<b>Title - Sujet</b> Nouveau havre à Harrington Harbour	
<b>Solicitation No. - N° de l'invitation</b> F3731-170101/A	<b>Amendment No. - N° modif.</b> 004
<b>Client Reference No. - N° de référence du client</b> F3731-170101	<b>Date</b> 2017-11-08
<b>GETS Reference No. - N° de référence de SEAG</b> PW-\$QCM-032-17241	
<b>File No. - N° de dossier</b> QCM-7-40184 (032)	<b>CCC No./N° CCC - FMS No./N° VME</b>
<b>Solicitation Closes - L'invitation prend fin</b> <b>at - à 02:00 PM</b> <b>on - le 2017-11-22</b>	<b>Time Zone</b> <b>Fuseau horaire</b> Heure Normale du l'Est HNE
<b>F.O.B. - F.A.B.</b> <b>Plant-Usine:</b> <input type="checkbox"/> <b>Destination:</b> <input checked="" type="checkbox"/> <b>Other-Autre:</b> <input type="checkbox"/>	
<b>Address Enquiries to: - Adresser toutes questions à:</b> Girard, Isabelle	<b>Buyer Id - Id de l'acheteur</b> qcm032
<b>Telephone No. - N° de téléphone</b> (418) 649-2847 ( )	<b>FAX No. - N° de FAX</b> (418) 648-2209

## AMENDMENT 004

### Title: Development of a Fishing Harbour, Harrington Harbour

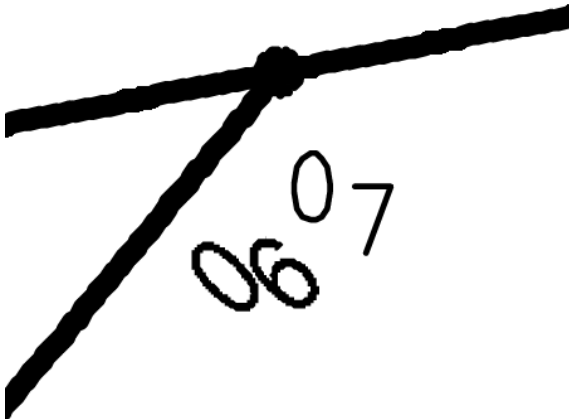
**Question 55 :** There appears to be an inconsistency between the drilling reports and the bathymetry provided.

Take the drill F-A13:

Thus, the consistency between drilling results and bathymetry does not seem to be consistent. Given the monetary and execution importance of this element, we want to have valuable data on hand.

Also, there are several points where rock bathymetry is encountered before the sediment layer or other material.

Several holes present this problem and the interpretation and calculations of sediment and gravel dredging are very annoying.

Given the situation, is it possible to know the quantities of each dredged material, including contaminated soil, to be able to establish a price reflecting the actual composition of the soil in place to excavated?

**Answer 55 :** We are aware of the inconsistencies between the geotechnical report and the bathymetry in the plans.

For your information, the consultant who did the geotechnical study did not use the chart datum to establish the bathymetries that are indicated in the drilling logs, whereas the bathymetric sounding on plans has been realized referenced to the chart datum.

To circumvent this situation, we have indicated the quantities of rock and sediment to be dredged in the specifications in section 01 29 00 (item 3.1). It consists of 1200 m<sup>3</sup> of sediment and 2900 m<sup>3</sup> of rock for a total of 4100 m<sup>3</sup>.

The contractor must establish its unit price with these quantities regardless of his interpretation of the drilling logs. Drilling logs are indicated for the main purpose of characterizing the rock. Note that only one unit price is required for both classes of materials.

The quantity of contaminated sediment to be dredged and disposed (> CEF) is indicated on the schedule in item 3.2, ie 1000 tm (or approximately 500 m<sup>3</sup>).

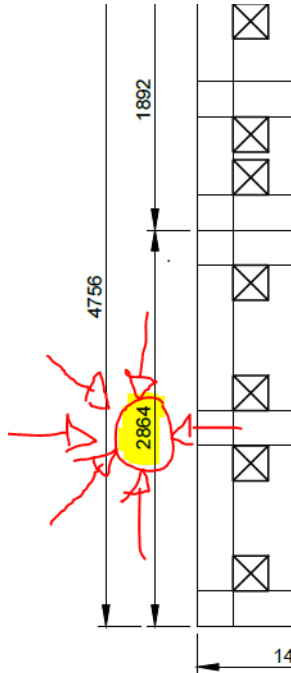
**Question 56 :** In connection with answer # 7 answered like this: "Is the question really about the dimensions 1893 versus 1892 and 2263 versus 2264? If so, consider that the dimensions are 1893 and 2263. Note that these dimensions will probably still adjust to the site. "

The dimension 2264 mm does not exist in the plane page 13 (Gateway block detail), It is rather 2864 than we compare to 2263.

Please confirm me the right measurement.

**Answer 56 :** In fact previous answer # 7 was not exactly right, but the answer remains the same, ie 1893 mm and 2263 mm.
